**BOARD OF ZONING ADJUSTMENT
STAFF REPORT****Date: April 7, 2014****CASE NUMBER**

5889

LOCATION154 Texas Street
(North side of Texas Street, 100'+ East of South
Conception Street)**VARIANCE REQUEST****SITE:** Site Variance to allow a continuous 52' wide property and alley curb cut; a 10' wide single lane driveway access to a rear storage yard; nose-in/back-out parking spaces with access and maneuvering within the public right-of-way; and no landscaping or tree planting compliance in an I-1, Light Industry District**ZONING ORDINANCE
REQUIREMENT****SITE:** The Zoning Ordinance requires site entrances and exits located so as to minimize traffic congestion; rear yard access drives to be two-way, 24' wide; all parking access and maneuvering to be on-site; and full compliance with the landscaping and tree planting requirements in an I-1, Light Industry District**ZONING**

SITE PLAN

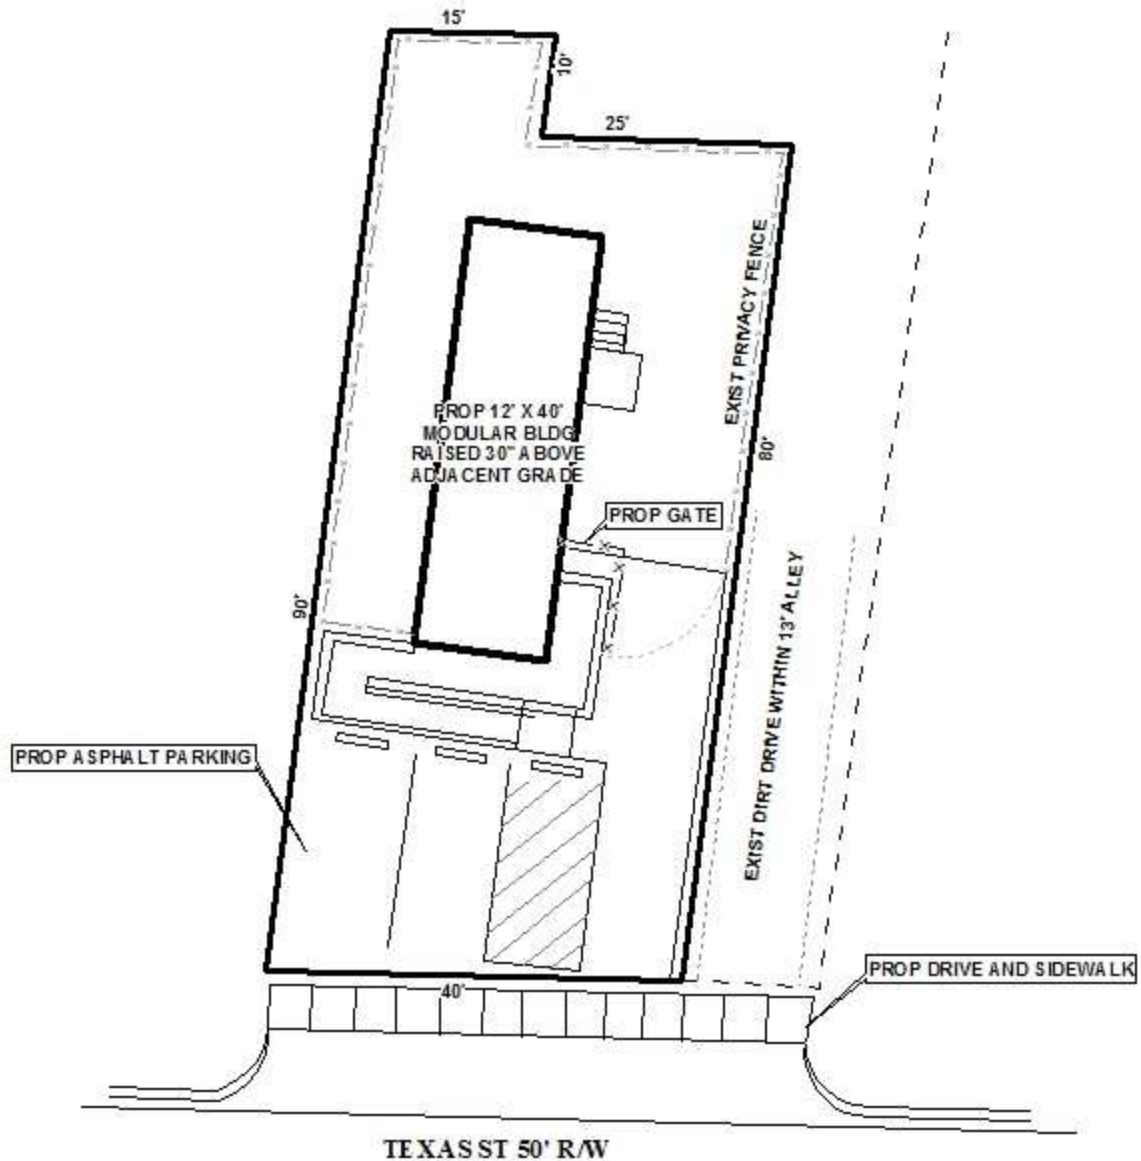
It is recommended that the access for the existing alley should be separated from the access to the subject property.

The proposed plan shows that the proposed curb cut will be constructed in front of adjacent properties to the East and West; therefore, if approved, the applicant would be required to submit a letter along with the Right-of-Way permit application, from the adjacent property owners, that allows the applicant to place a portion of the proposed driveway curb-cut in front of their property (City of Mobile Right-of-Way Construction and Administration Ordinance, Section 57-124).

Backing into the right-of-way is not desirable, especially in this location given the transition in the roadway alignment of Texas Street. The continuous curb cut across the front of the property and the alley may give a false impression that the alley has been incorporated into the subject property and is no longer public right-of-way. Driveway improvements cannot extend beyond the property line without the consent of the adjacent property owner. As illustrated on the site plan, it would apply to the property owner on the east side of the alley, as well as the adjacent property owner to the west.

As proposed, the applicant appears to be overdeveloping the site, as evidenced by the numerous variance requests. Additionally, only frontage trees are required in I-1 districts, thus the applicant is only required to provide 1 frontage tree in order to be in compliance.

The property, located in an I-1, Light Industry district, abuts residences at the Northwest corner of the property. Amendments to Section 64-4.D.1. of the Zoning Ordinance in 2012 require that commercial uses next to residential uses (even when in the same zoning district) must provide a 10-foot protection buffer: the site plan depicts a more than adequate buffer, and in fact the buffer depicted on the site plan could be reduced, which would allow the proposed modular building to

be placed further North and West on the site. By moving the location of the modular building, additional area for parking and the proposed driveway would be available. It appears, in fact, that a redesign to allow two parking spaces on-site, facing West, would thus allow a 22 ± foot wide driveway and eliminate the backing into Texas Street. This redesign would also provide enough room to allow sufficient landscape area to plant one overstory tree, and provide some level of landscape area compliance.

Based on the preceding, staff recommends that the request be heldover to the May meeting to allow the applicant to make the following revisions to the site plan, due by April 14, and possibly revise the variances requested:

- 1) Revision of the site plan to reflect the absolute minimum setback required by Section 64-4.D.1. of the Zoning Ordinance;
- 2) Repositioning of the proposed modular building to reflect the setbacks of condition #1;
- 3) Realignment of the two parking spaces, access aisle, and accessible area to show the two parking spaces facing West;
- 4) Depiction of one frontage tree and calculations of available landscape area;
- 5) Revision of the requested variances, if necessary, to reflect site layout changes; and
- 6) Clarification of how employees will park if they come to this location to receive their checks.
